City of Portland, Maine - Building or Use Permit Application

Location of Construction: 41 BAYBERRY LN, <i>Peaks</i>	Owner Name: LIEBER ROBERT A	Owner Address: 41 BAYBERRY LN	Phone:
Business Name:	Contractor Name: homeowner	Contractor Address: Portland	Phone:
Lessee/Buyer's Name	Phone:	Permit Type: Single Family	Zone: IK-1

Proposed Project Description: build a 486 sq ft home	EXPIRED	
Signature: _____	Signature: _____	Signature: _____
CITY OF PORTLAND PLANNING AND COMMUNITY DEVELOPMENT DEPARTMENT (P.C.D.)		
Action: <input type="checkbox"/> Approved <input type="checkbox"/> Denied	Conditions: <input type="checkbox"/> Approved <input type="checkbox"/> Denied	Conditions: <input type="checkbox"/> Approved <input type="checkbox"/> Denied
Signature: _____	Date: _____	Date: _____

CHECK-LIST AGAINST ZONING ORDINANCE

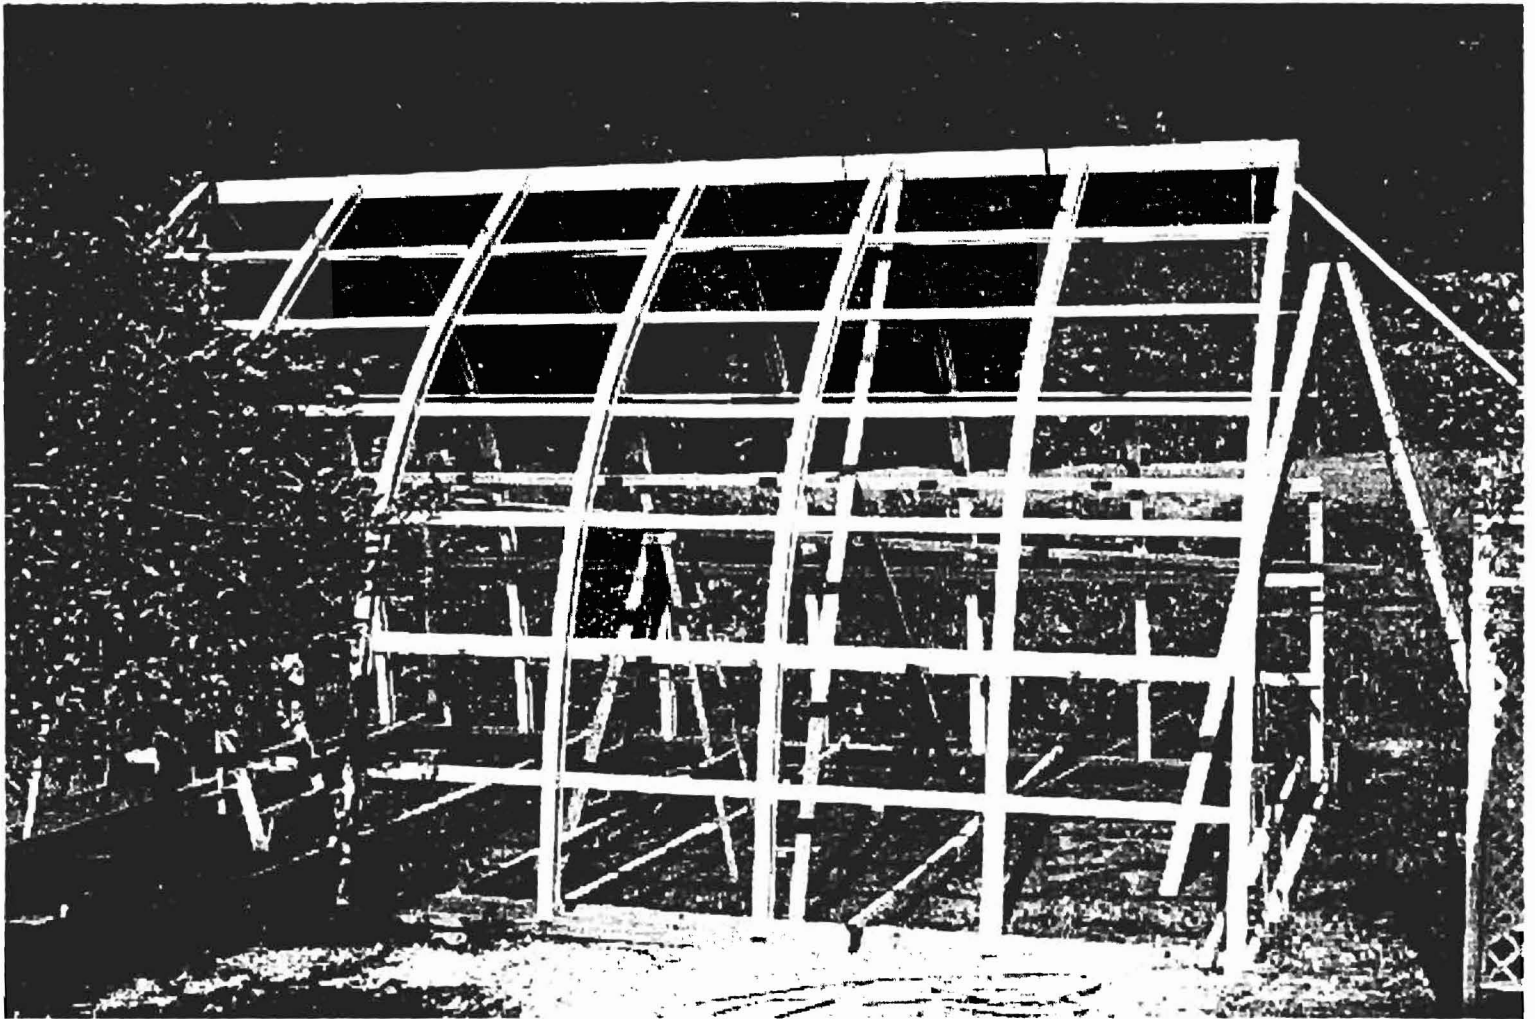
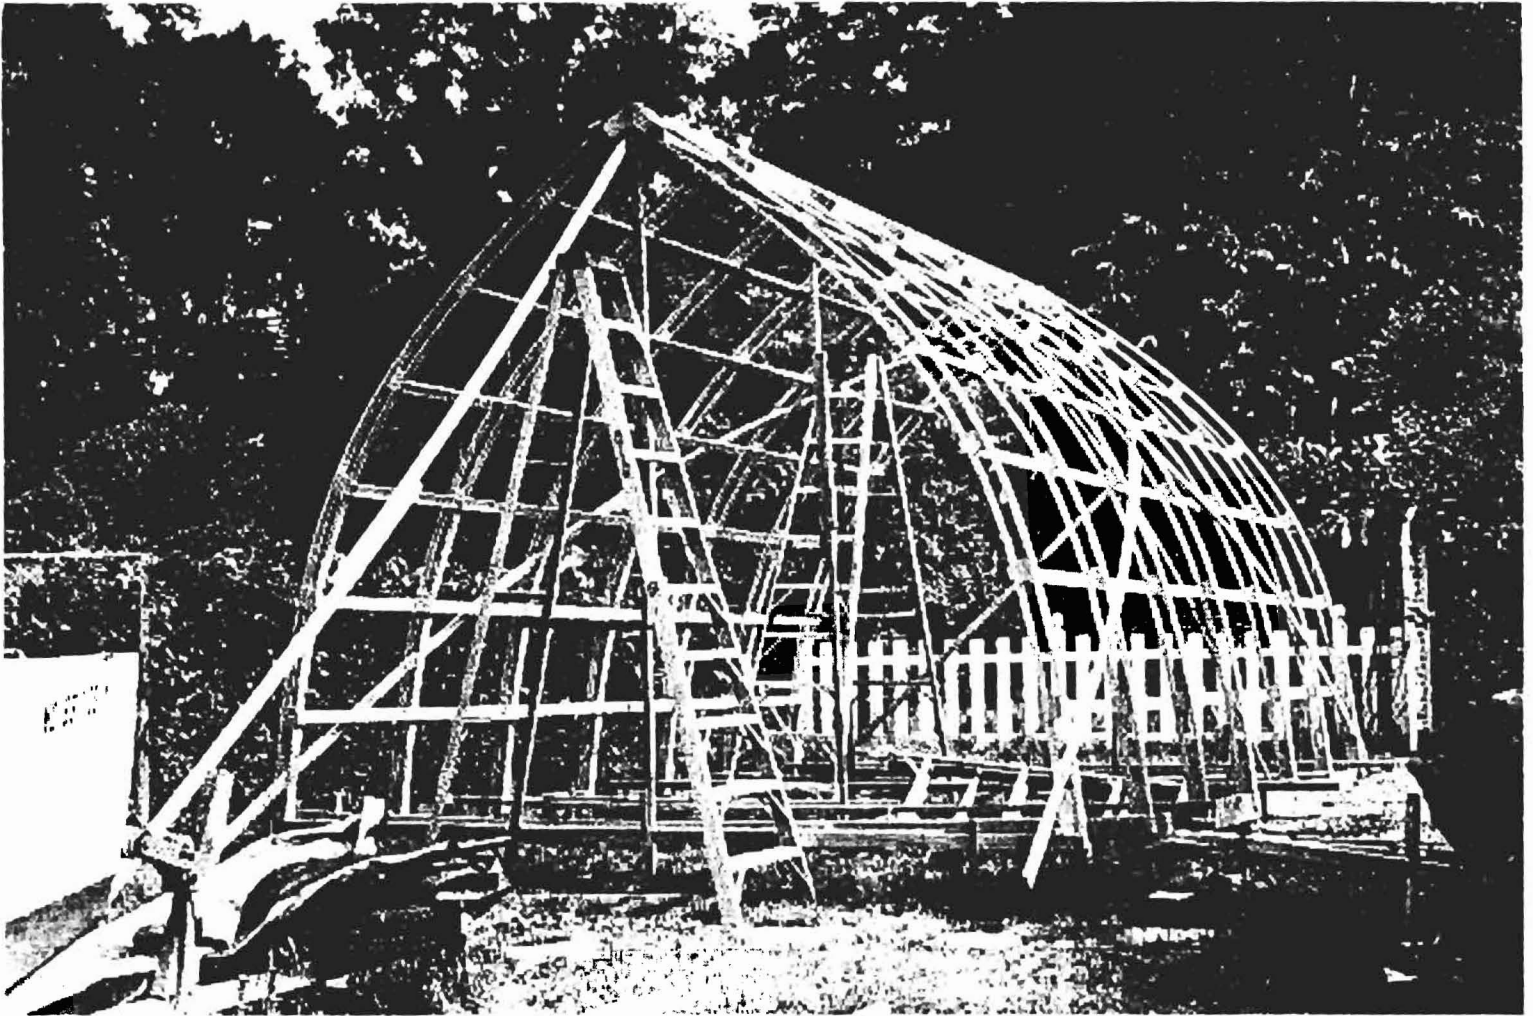
ONE AND TWO FAMILY	PLAN REVIEW	CHECKLIST		
Soil type/Presumptive Load Value (Table R401.4.1)				
Component	Submitted Plan	Findings	Revisions	Date
STRUCTURAL Footing Dimensions/Depth (Table R403.1 & R403.1(1), (Section R403.1 & R403.1.4.1)	16" x 8" 8" Keena Forms		OK	
Foundation Drainage, Fabric, Damp proofing (Section R405 & R406)	Pipe-wrapped-stone Tar-pu Robl.		OK	
Ventilation/Access (Section R408.1 & R408.3) Crawls Space ONLY	N/A			
Anchor Bolts/Straps, spacing (Section R403.1.6)	At Top plate / Roof rafters		OK	
Lally Column Type (Section R407)	N/A			
Girder & Header Spans (Table R 502.5(2))				
Built-Up Wood Center Girder Dimension/Type	N/A			
Sill/Band Joist Type & Dimensions	N/A			
First Floor Joist Species Dimensions and Spacing (Table R502.3.1(1) & Table R502.3.1(2))	Slab		OK	
Second Floor Joist Species Dimensions and Spacing (Table R502.3.1(1) & Table R502.3.1(2))	2x12 16" O.C. protect wood/conc		OK need more struc. info	○

Type of Heating System	? wood stove ? 2nd FL.	vent Floor OK 8
Means of Egress (Sec R311 & R312) Basement	NA Slab	OK
Number of Stairways	1	
Interior	1	
Exterior	0	
Treads and Risers (Section R311.5.3)	7' 1/4 R - 10" - T	
Width (Section R311.5.1)	3'6" scaled	
Headroom (Section R311.5.2)	? 6'	6'8" per Rob L. 9/29/06
Guardrails and Handrails (Section R312 & R311.5.6 - R311.5.6.3)	34"	OK
Smoke Detectors (Section R313) Location and type/Interconnected	As noted ? study	Will Add 9
Draftstopping (Section R502.12) and Fireblocking (Section (R602.8)	N/A	
Dwelling Unit Separation (Section R317) and IBC - 2003 (Section 1207)		
Deck Construction (Section R502.2.1)	N/A

Site Plan

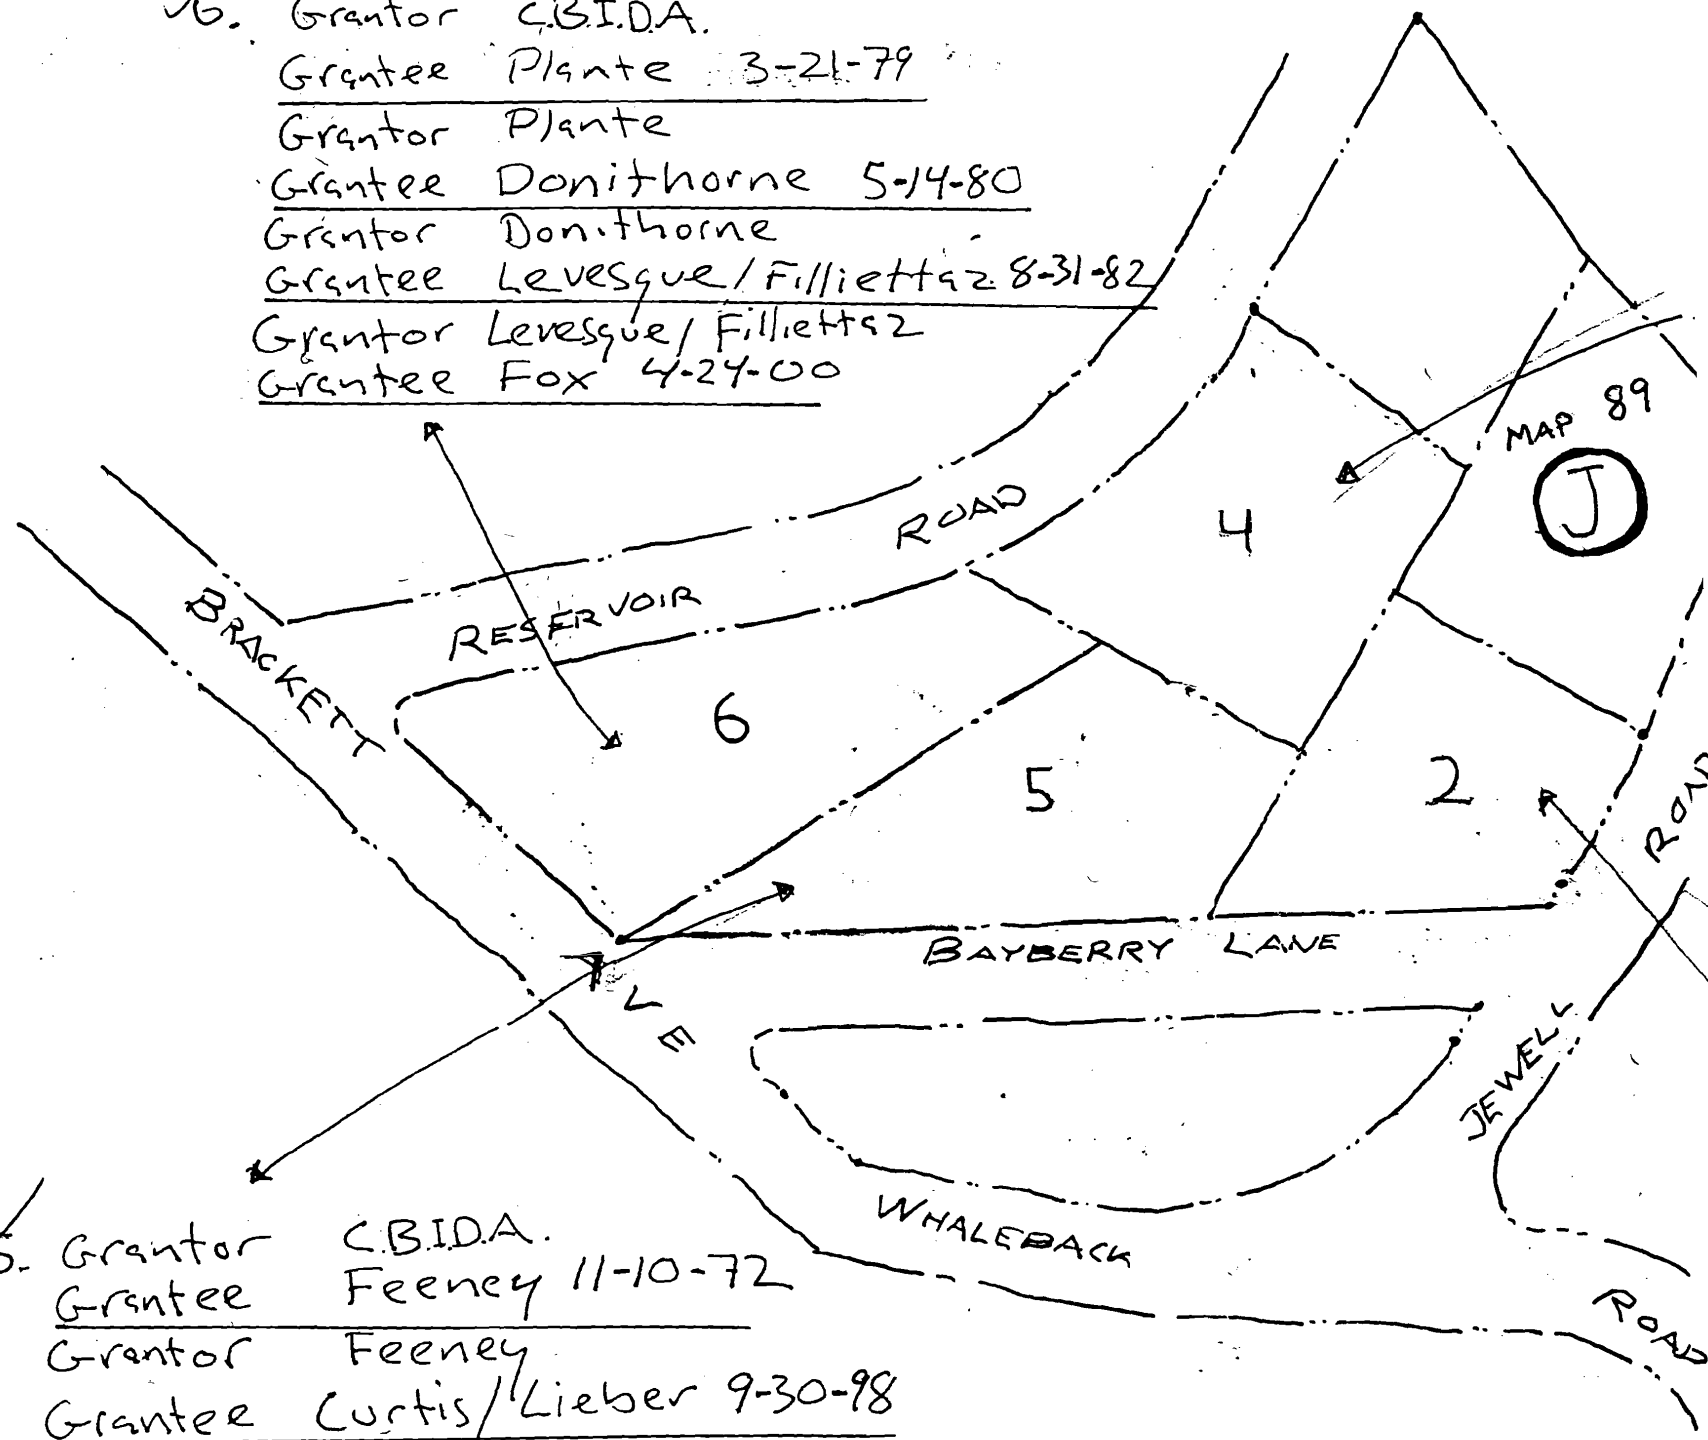
9/18/2006-amachado: Chain of title is complete. Site plan is stamped. Still on hold because storage building does not meet rear setback. Moving permit forward to residential plan reviewers but don't issue until location of storage building is resolved. Spoke to Robert Leiber and told him that he needed a revised siteplan showing that the outbuilding meets the rear setback.

11/9/2006-amachado: Received revised site plan. Accessory building still does not meet the rear setback. Left message with Rob Lieber.

11/13/2006-amachado: Spoke to Rob Leiber. He will bring in a revised plan.

Rear Yard - 30' min = 58' scaled (house) / 25' scaled " 25' scaled
